Addendum

HC908JB16AD/D
Rev. 1, 8/2002

Addendum to
MC68HC908JB16
Technical Data

Figure 1. 20-Pin SOIC Pin Assignment

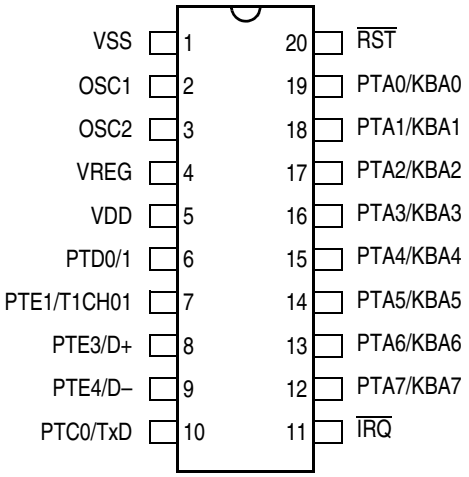
20-Pin SOIC *Order Number:* ***MC68HC908JB16JDW***

Pins not available on 20-pin package:		
PTC1/RxD	PTE0/TCLK	PTD2
	PTE2/T2CH01	PTD3
CGMXFC1	CGMXFC2	PTD4
CGMOUT1	CGMOUT2	PTD5
VREGA0	VREGA1	
VSSA0	VSSA1	VDDA

Internal pads are unconnected.

PTD0/1 pin: PTD0 and PTD1 internal pads are bonded together to PTD0/1 pin, and has 50mA sink capability when configured as an output. Pin direction must be configured such that DDRD0 = DDRD1.

Figure 2. 20-Pin SOIC Mechanical Dimensions (Case No. 751D)

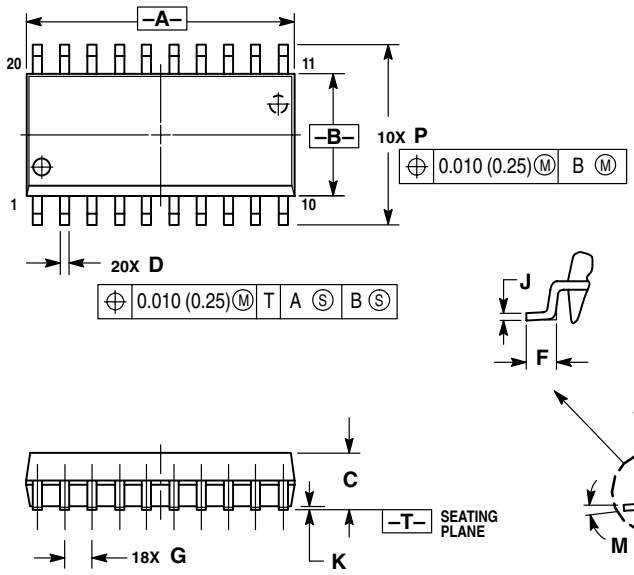
This section updates data sheet information and introduces the 20-pin SOIC package for the MC68HC908JB16.

Figure 3. MC68HC908JB12 Block Diagram

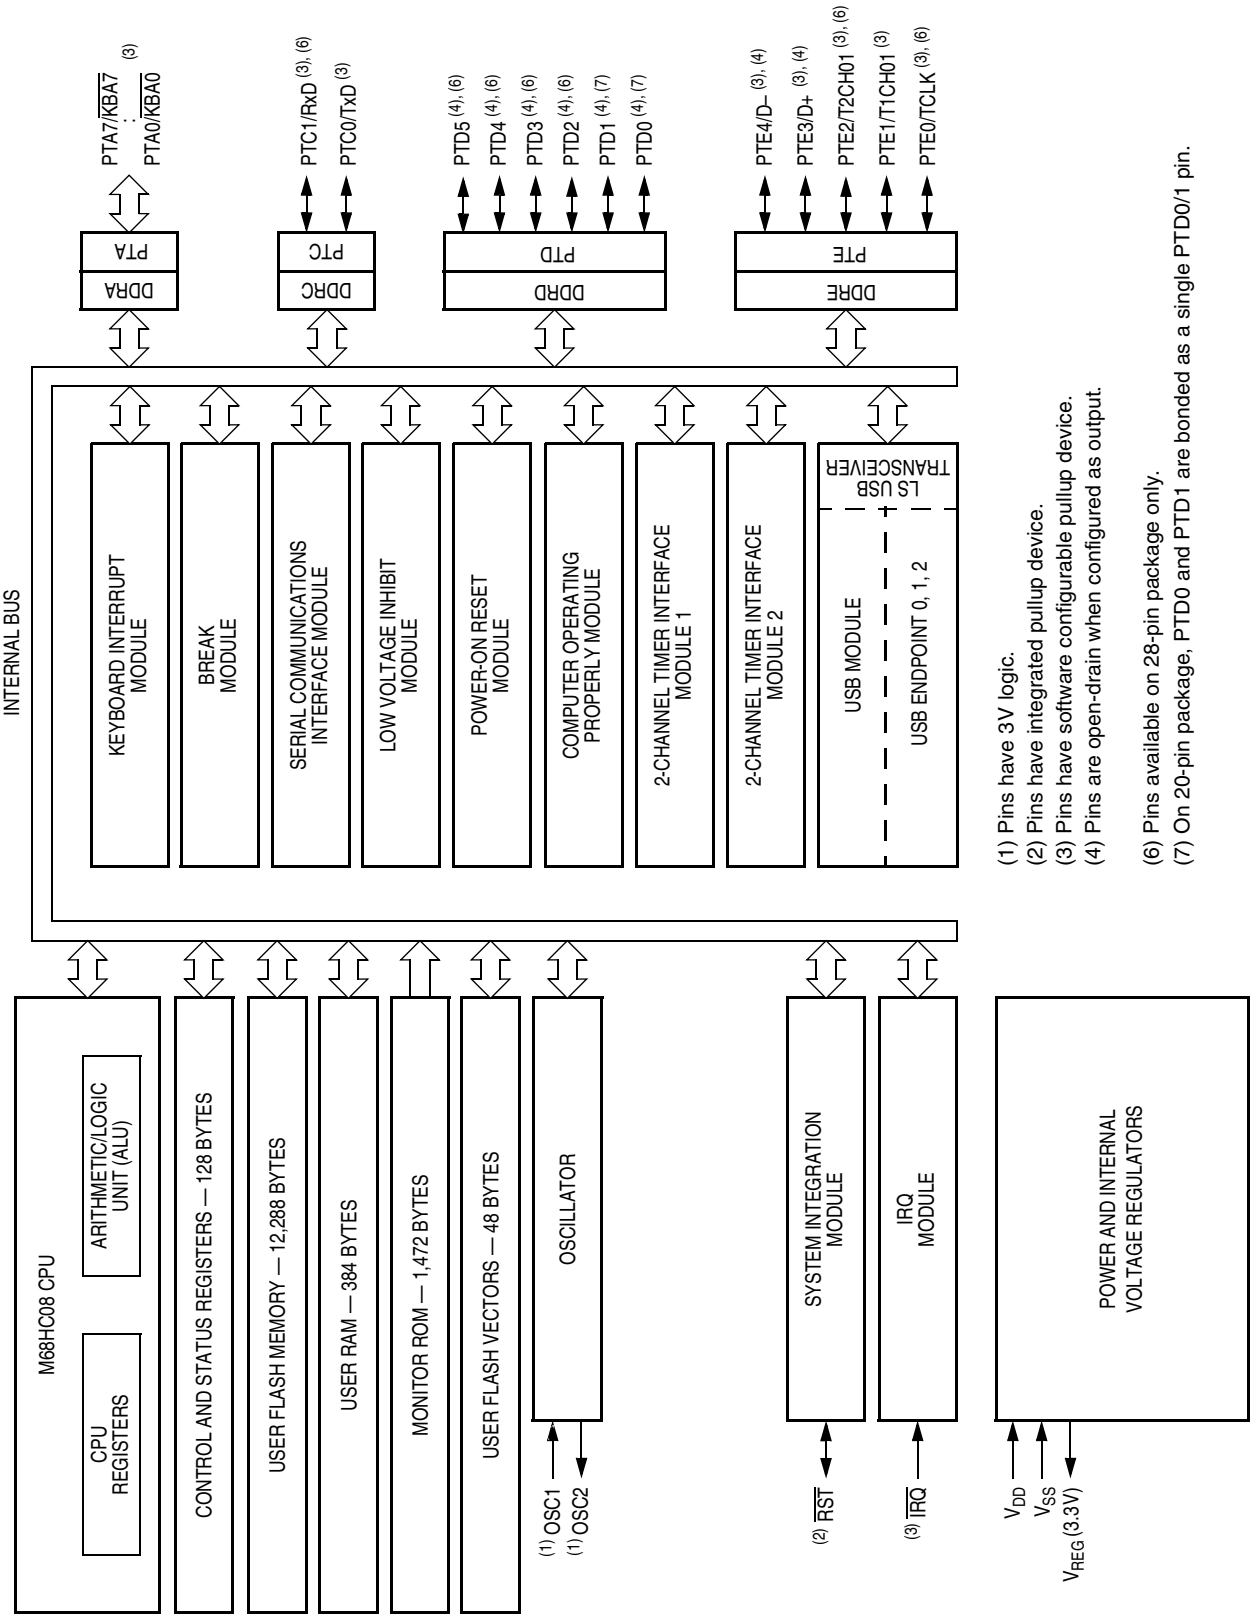
Figure 3 shows the structure of the MC68HC908JB12.

The dual 27-MHz clock generator module on the MC68HC908JB16 is not designed in the MC68HC908JB12, hence, register locations from $0051 to $0059 are unimplemented. Information in the data book relating to the CGM do not apply to the MC68HC908JB12.

Figure 4. MC68HC908JB12 Memory Map

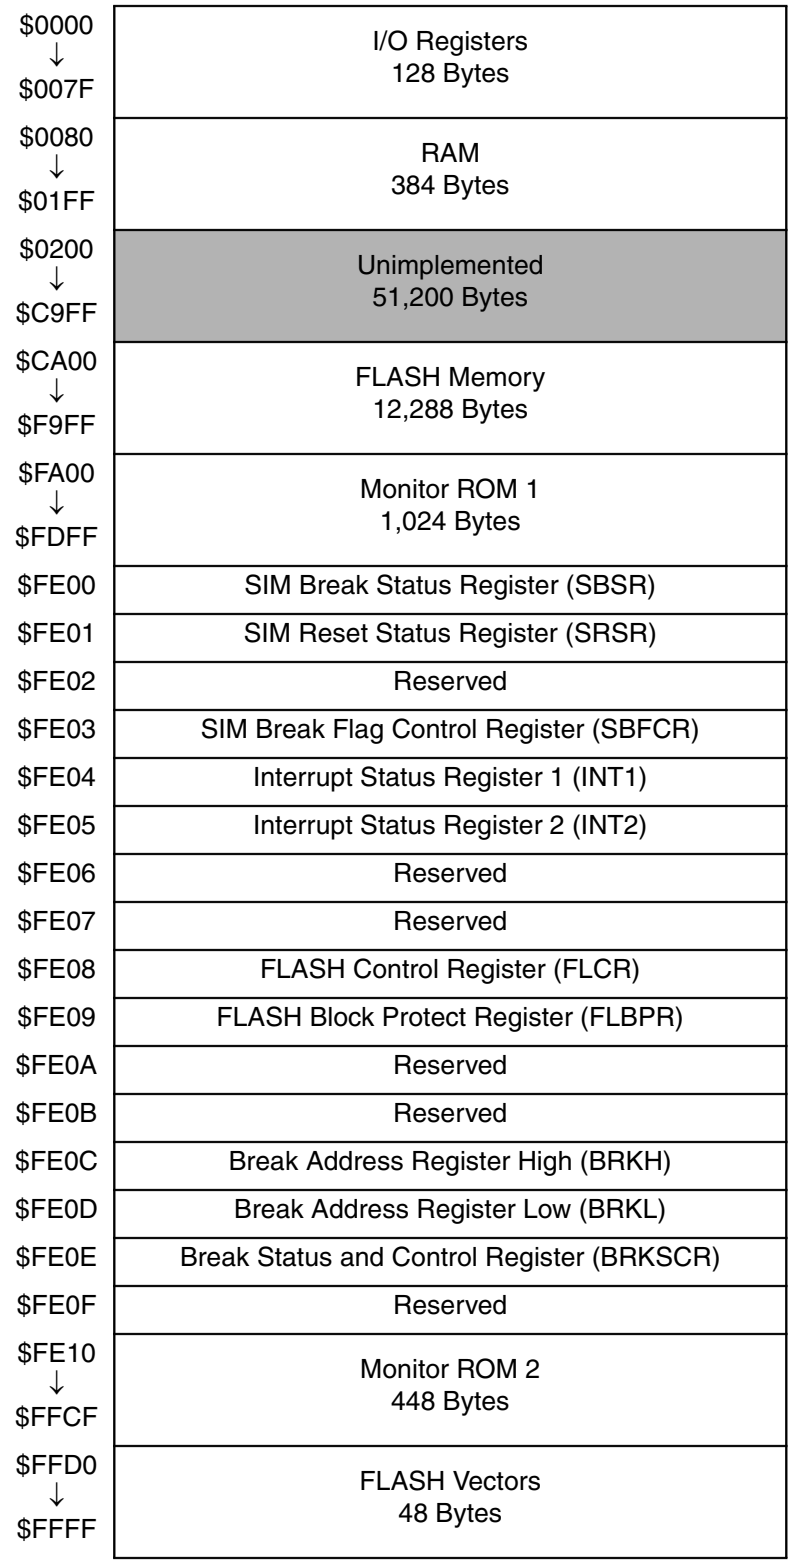
Figure 4 shows the memory map of the MC68HC908JB12.

Figure 5. MC68HC08JB16 Block Diagram

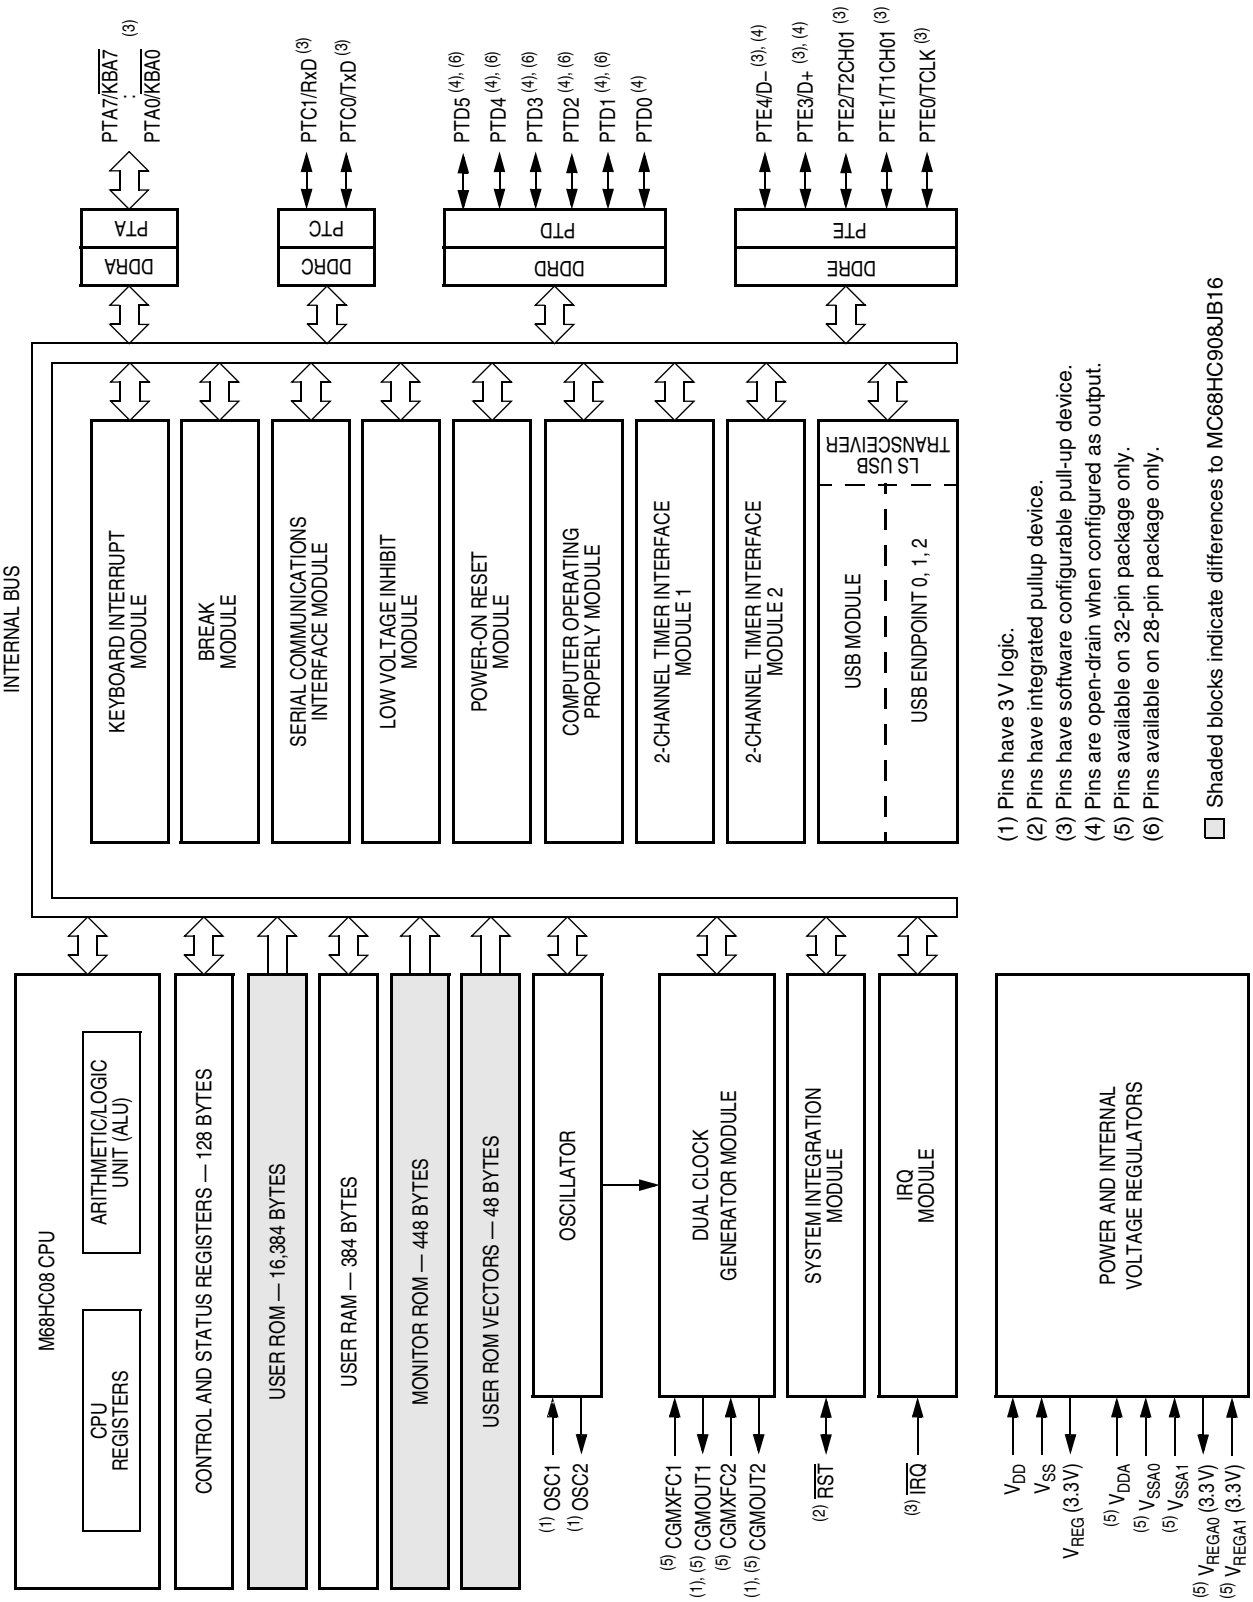
Figure 5 shows the block diagram of the MC68HC08JB16.

Figure 6. MC68HC08JB16 Memory Map

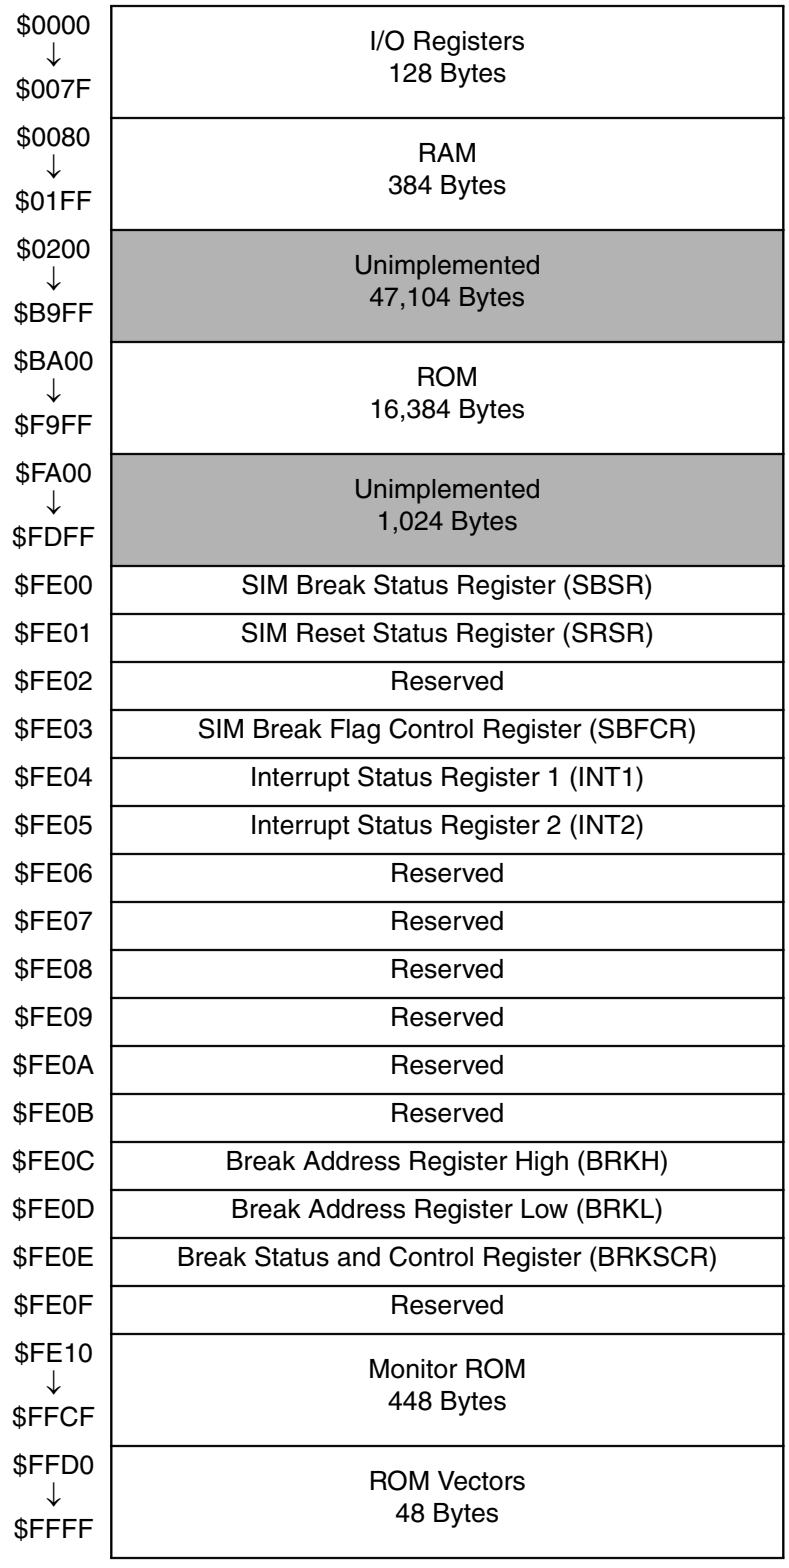
Figure 6 shows the memory map of the MC68HC08JB16.

The two registers at $FE08 and $FF09 are reserved locations on the MC68HC08JB16.

The monitor program (monitor ROM, $FE10–$FFCF) on the MC68HC08JB16 is for device testing only.
